Access Compliance Report

Public Rights-of-Way

(Curb Ramps)

Intersection ID: N/A	Main Street: VILLAGE_WALK_RD	Cross Street: HOUSTON_FIELD_CT	Location: SW
ADA ID: 6E8810EB5293	Ramp Type: Perp	Initial Pass/Fail: Fail	Overall Compliance: No
Codes/Mitigation Info/Possible Solution		Field Measurements/Component Compliance	
Severity Score: 13.75

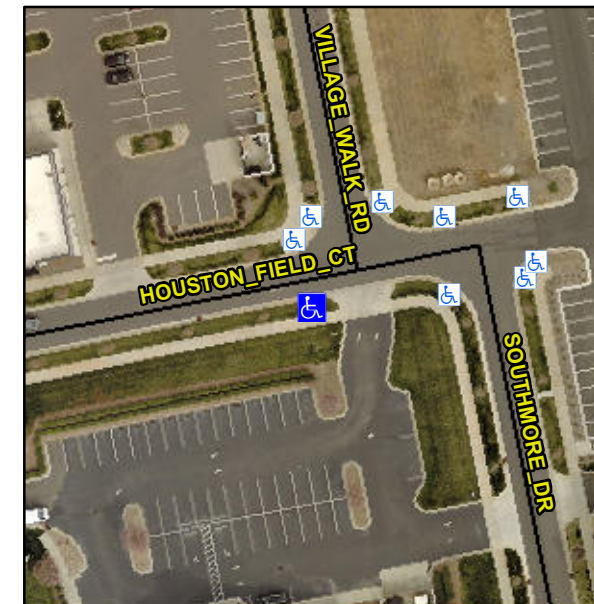
Not Found, R304.2.2

Compliance	Description	Data	Compliance	Description	Data
N/A	Ramp Length (in)	96.0	No	Ramp Slope (%)	8.8
Yes	Ramp Width (in)	70.0	Yes	Ramp XSlope (%)	2.6
N/A	Flare Type LT	N/A	N/A	Flare Type RT	N/A
N/A	Flare Slope LT (%)	N/A	N/A	Flare Slope RT (%)	N/A
N/A	Flare Traversable LT?	N/A	N/A	Flare Traversable RT?	N/A
N/A	Landing Length (in)	N/A	N/A	DWS Provided?	N/A
N/A	Landing Width (in)	N/A	N/A	DWS Contrast?	N/A
N/A	Landing Slope (%)	N/A	N/A	DWS Length (in)	N/A
N/A	Landing X Slope (%)	N/A	N/A	DWS Full Width?	N/A
N/A	Landing Curb? (Y/N)	N/A	N/A	DWS Offset (in)	N/A
N/A	Shared Landing?	N/A			
N/A	Gutter Ponding?	N/A	N/A	Gutter Slope (%)	N/A
N/A	Gutter Lip Ht (in)	N/A	N/A	Gutter X Slope (%)	N/A
N/A	Painted X Walk1?	No	N/A	Painted X Walk2?	N/A
	X Walk 1 Direction	To N		X Walk 2 Direction	N/A
N/A	X Walk 1 Width (in)	N/A	N/A	X Walk 2 Width (in)	N/A
	X Walk 1 Slope (%)	3.4		X Walk 2 Slope (%)	N/A
	X Walk 1 X Slope (%)	4.6		X Walk 2 X Slope (%)	N/A

Remove & Replace Entire Ramp.
